Comments on OICA proposal

UNECE GRSP Task Force
Deployable Bonnet Systems for Pedestrian Safety
2nd meeting, 28 – 29 Mar. 2017

1. Definition of Test Area (Appendix)

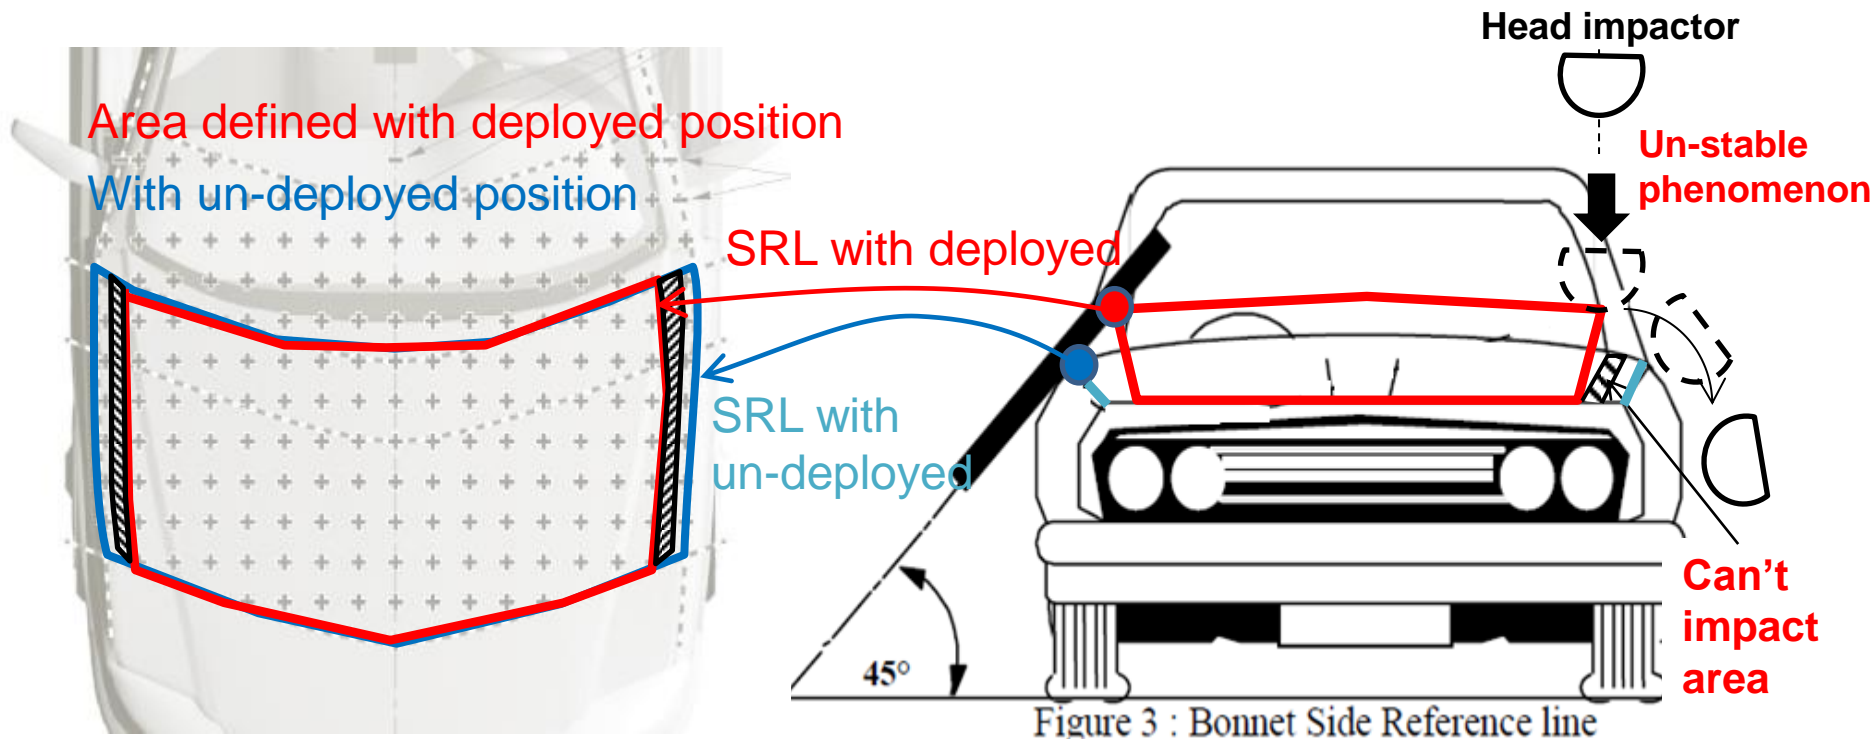
In case of an active system, that can be kept deployed fully before head contact, the determination of evaluation head impact area should be defined in the deployed position of the exposed outer surface. Otherwise, should be defined with un-deployed condition.

- Deployed position is the position where an accident victim actually comes in contact with the bonnet.
- The area defined with Un-deployed position may lead to unstable impact test results

The area defined with Un-deployed position may lead to unstable impact test results :

1. The impactor rolls off at the edge of the hood leading to un-stable results.
2. Some areas exist on the outer surface which can NOT be impacted directly on the target point.
